Interactive comment on “Regional effects of vegetation restoration on water yield across the Loess Plateau, China” by X. M. Feng et al.

Comments from reviewer #2:

Fig. 3. Revised figure 5

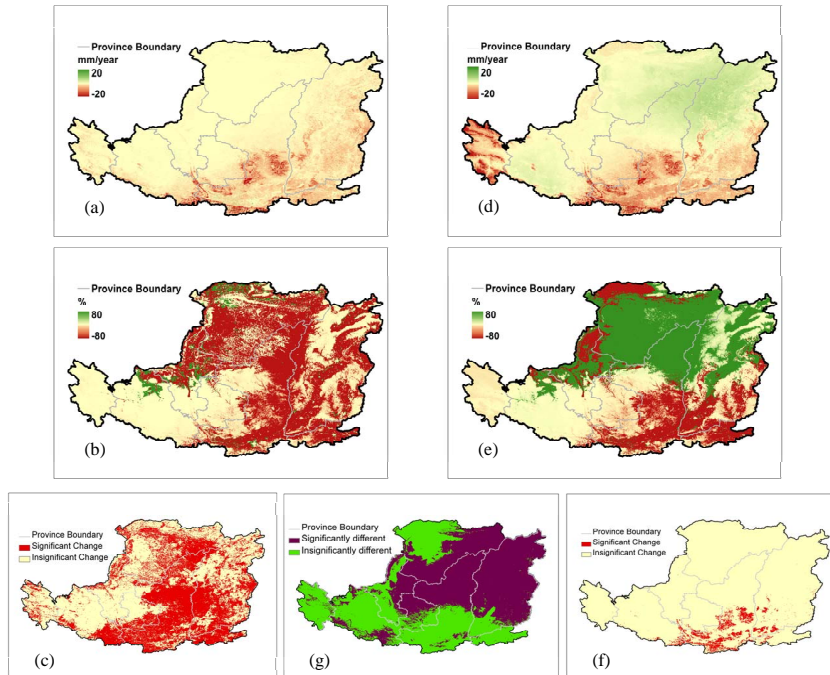
I also certainly miss a uncertainty estimation for the parameter of the regression model and the resulting uncertainty in the results. Right now it is not clear to me if any of the results are significant. There are no error/uncertainty bars at any of the graphs.

found that 61%, 3.5% and 17% of monthly ET variability was explained by the terms $PET \cdot PPT$, $PPT \cdot LAI$ and $PET \cdot LAI$, respectively. All variables in the above equation were highly significant ($p < 0.0001$).” We have added the statistically significant analysis on water yield change and created the map showing the difference in water yield trend between scheme 1 and scheme 2. We have added descriptions of testing the significance of the difference in water yield trend between scheme 1 and scheme 2 in the method section (section 2.4). We have also revised the result section (section 3.2) and figure 5, 6.

Revision on the results (section 3.2): “3.2 Spatial Variability of Annual Water Yield 3.2.1 Effects of Land Cover Change Only The results of trend analysis suggested that vegetation restoration only during the study period caused annual water yield to decrease as much as 1.6 mm per year on average across the Loess Plateau (Fig. 5a). Divided the trend in water yield over the period 1999–2007 by the baseline conditions in 1999, change in water yield can also be expressed in a relative term (Fig. 5b). About 26% of the study region located in the southeast portion (i. e., southern Shaanxi and Shanxi Provinces) had a significant decrease trend ($P < 0.05$, T-test) in water yield with a range of 1–48 mm per year, among which a small portion (6%) experienced a decrease trend greater than 10 mm per year. About 19% of the study region located in the north portion

(i.e., northern Shaanxi and Inner Mongolia Province) experienced less but also significant decrease ($P < 0.05$, T-test) (Fig. 5a, Fig 5c, Fig. 6a). Because of the low baseline in these dry areas, the decrease less than 1 mm per year caused a relative value greater than 100% in water yield (Fig. 5b, Fig. 6b). 3.2.2 Effects of Land Cover Change + Climate Variability The combined water yield responses to land cover change and climate variability during 1999-2007 decreased by 1.0 mm per year on the Loess Plateau as a whole. The significant difference in water yield trend between the combined scenario and land cover only occurred in northern Shaanxi, Shanxi and Inner Mongolia Province (Fig. 5g). Because of the climate effect, the previous significant decrease in water yield in these areas became to an insignificant increase with a range of 1-10 mm per year (Fig. 5d). As expected, small changes in water yield amount resulted in a large relative change in the dry portion (northern Shaanxi, northwestern Shanxi and Inner Mongolia Province) due to their low background (Fig. 5e, Fig. 6c). Because of the climate effect, about 37% of the study area saw a decrease in water yield within a range of 1–54 mm per year. Only 4% of the study region (southern Shaanxi Province and southwestern Shanxi Province) has undergone a significant decrease ($P < 0.05$, T-test) in water yield of more than 5 mm per year (Fig. 5f, Fig. 6a).”
